# Wollongong Local Planning Panel Assessment Report | 1 December 2020

<b>WLPP No.</b>	Item No. 5
<b>DA No.</b>	RD-2019/1268/A
<b>Proposal</b>	Residential - demolition of outbuildings, Subdivision - Torrens title - two (2) lots, alterations to existing dwelling and construction of attached dual occupancy and Subdivision - Strata title - two (2) lots of proposed Lot 212
<b>Property</b>	8A Kembla Street, BALGOWNIE
<b>Applicant</b>	SRP Design & Drafting Pty Ltd
<b>Responsible Team</b>	Development Assessment and Certification - City Centre Major Development Team
<b>Development cost</b>	\$605,000
<b>Lodgement date</b>	22 August 2020
<b>Prior WLPP meeting</b>	NA

## ASSESSMENT REPORT AND RECOMMENDATION

CONCEPT SUBDIVISION PLAN

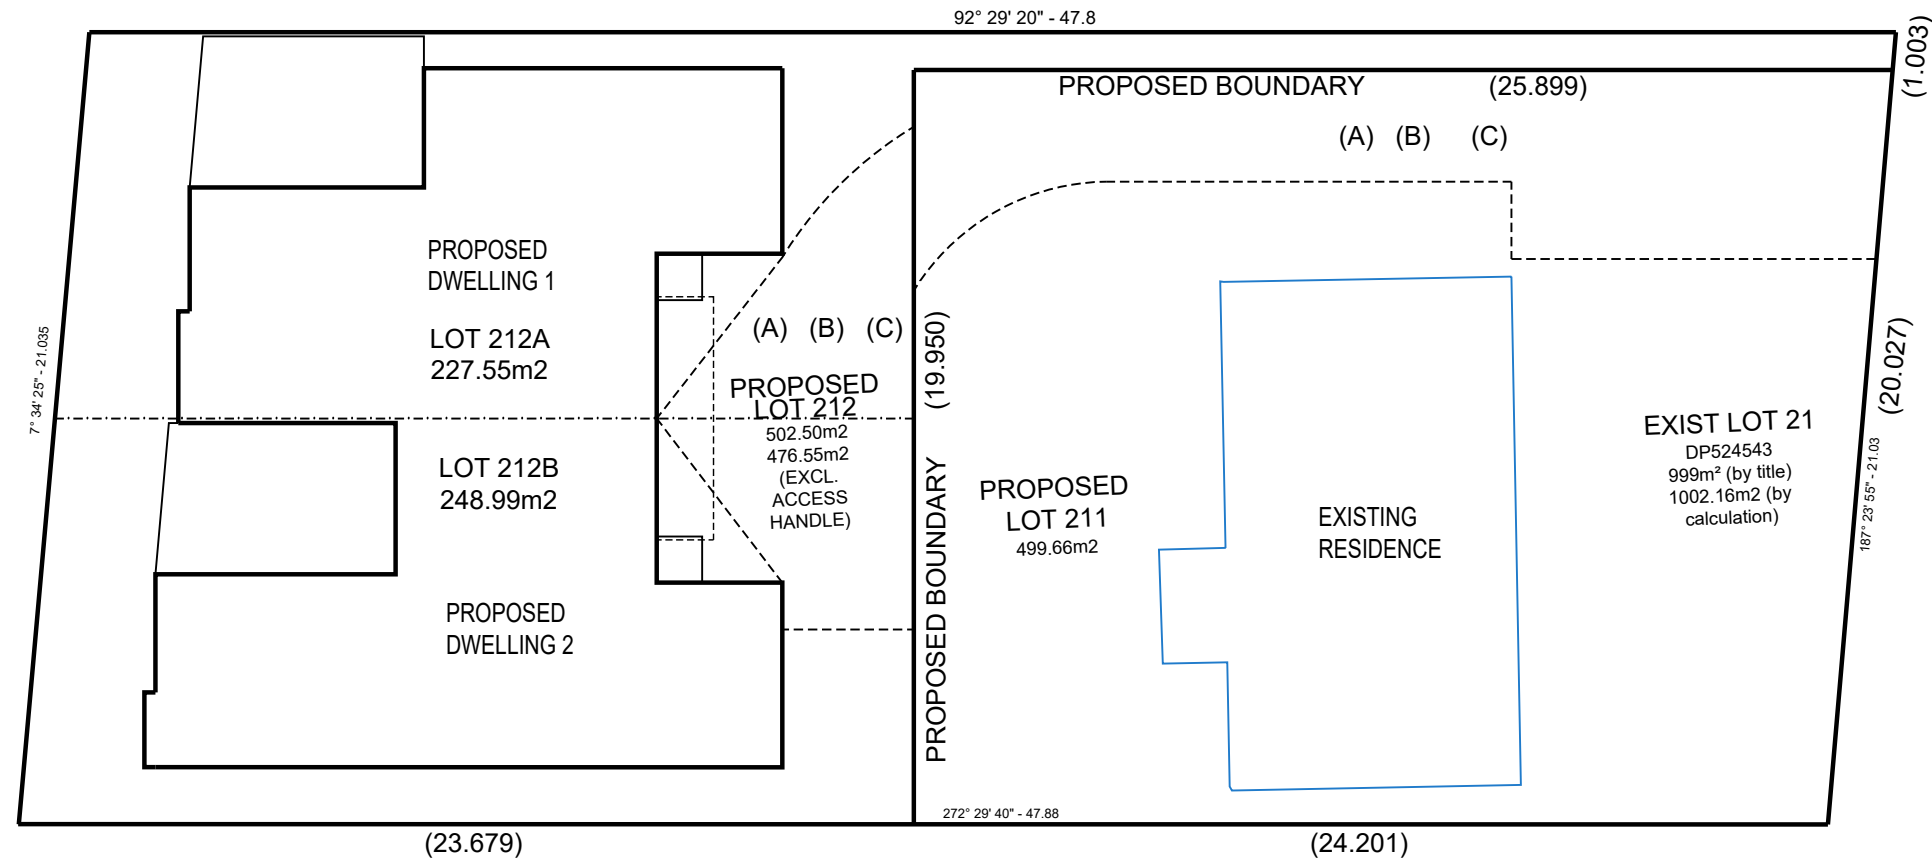
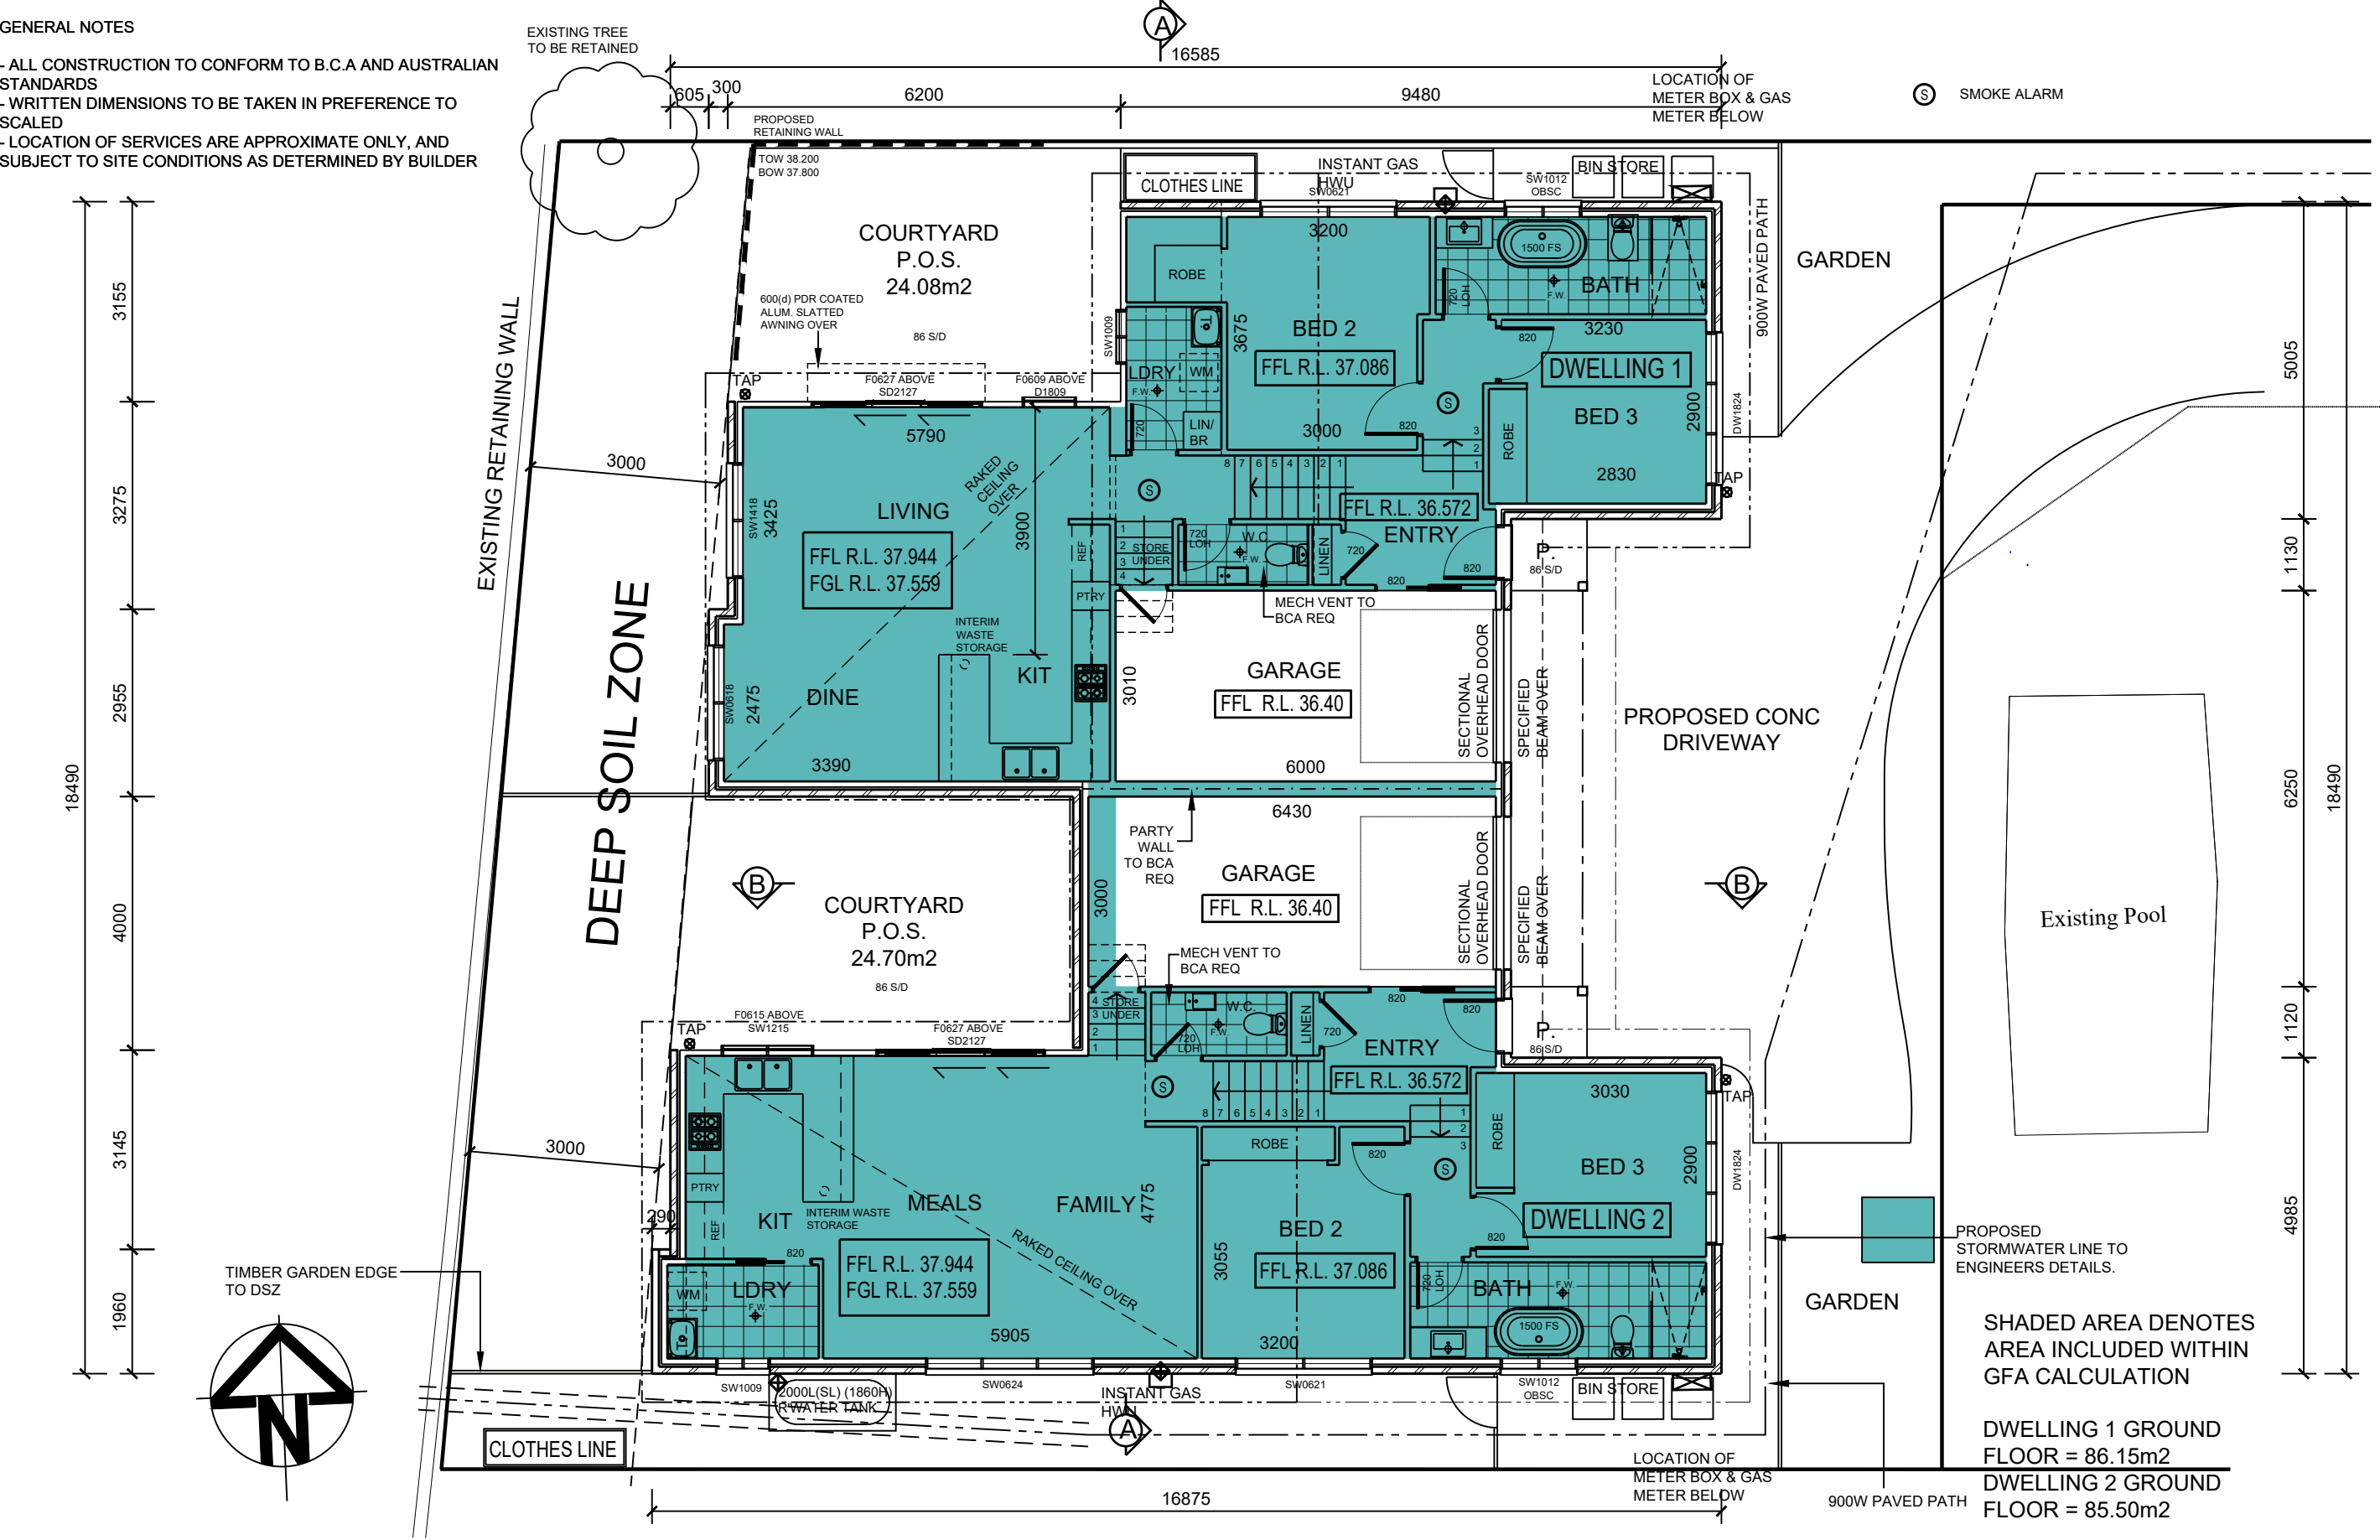
- 6 *Pursuant to the provisions of Section 4.15 (1)(b) of the Environmental Planning and Assessment Act 1979, the proposed development fails to demonstrate that the proposed right of carriageway between Lots 211 and 212 adequately encompasses the vehicle path between the allotments.*

The proposed subdivision plan has been amended to allow for right of carriageway for access to the garages of the proposed dual occupancy. Each garage will have right of access across the front of the other unit to facilitate manoeuvring to exit the site in a forward direction.
